Remarks

Applicant:	CHAUVIN	Examiner:	C. COHEN
Serial No.:	09/484,344	Group Art Unit:	3634
Filed:	JANUARY 18, 2000	Docket No.:	9320.95US01
Title:	MANUFACTURING PROCESS FOR AN AUTOMOBILE VEHICLE DOOR, AND THE CORRESPONDING DOOR

Fig. 1
PRIOR ART

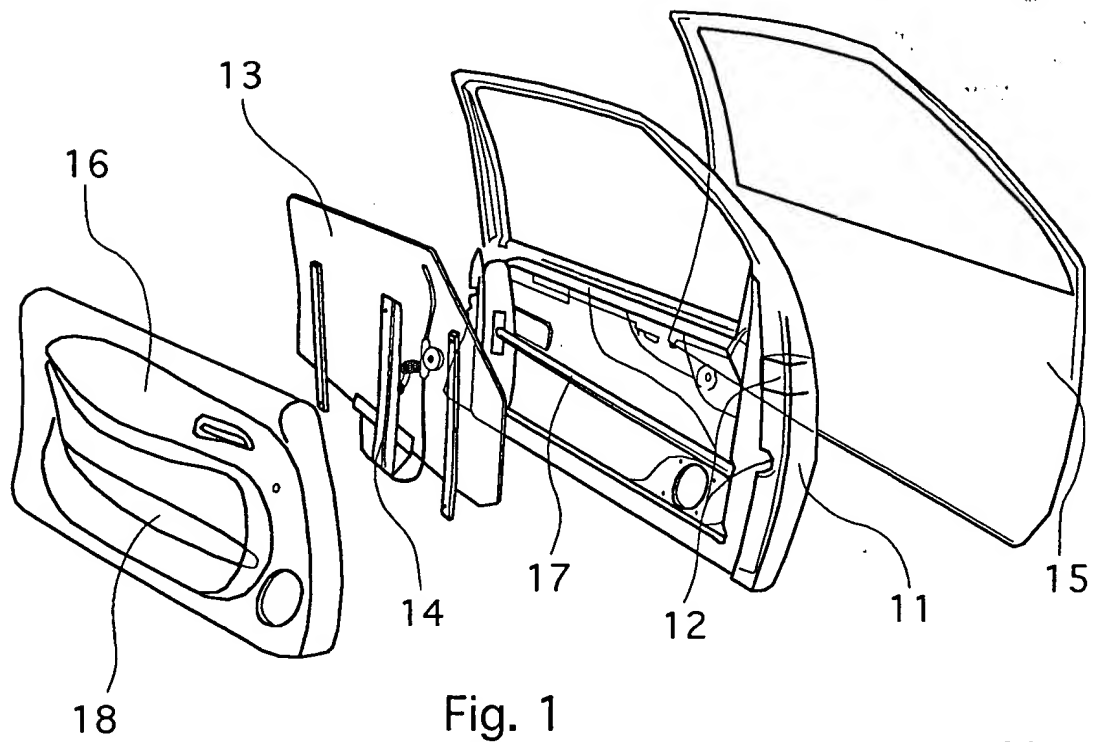
Figure 1 is objected to as not including a legend identifying it as prior art. Applicant respectfully traverses the objection. Applicants submit herewith an amended copy of Figure 1, including such a legend. Applicants believe the amendment overcomes the objection.

Fig. 2

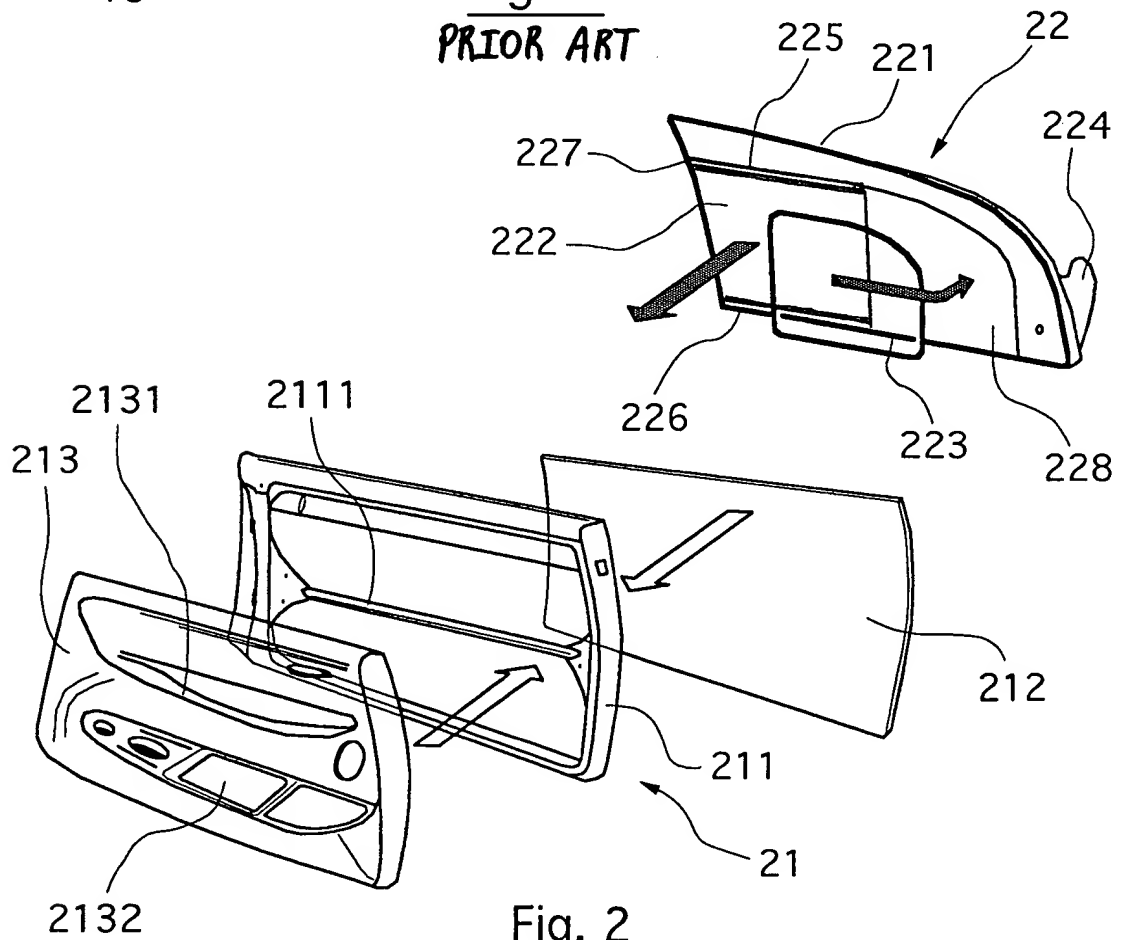
In addition, Applicant respectfully submits that the phrase “it can be opened” refers not to the window 222, but to the upper part 22. That is, it is desirable that the upper part 22 defines opening 228 therein. Applicant respectfully submits that this arrangement is visible in Figure 2. Nevertheless, Applicant regrets any confusion that may have resulted from the description. The specification is amended herein to clarify the relationship between the upper part 22, the window 222, and the opening 228.

With regard to the illustration of the guide means 225 and 226, Applicant thanks the Examiner for his constructive criticism. Figure 2 is amended herein to distinguish the guide means 225 and 226 from the edges of the fixed assembly 222.
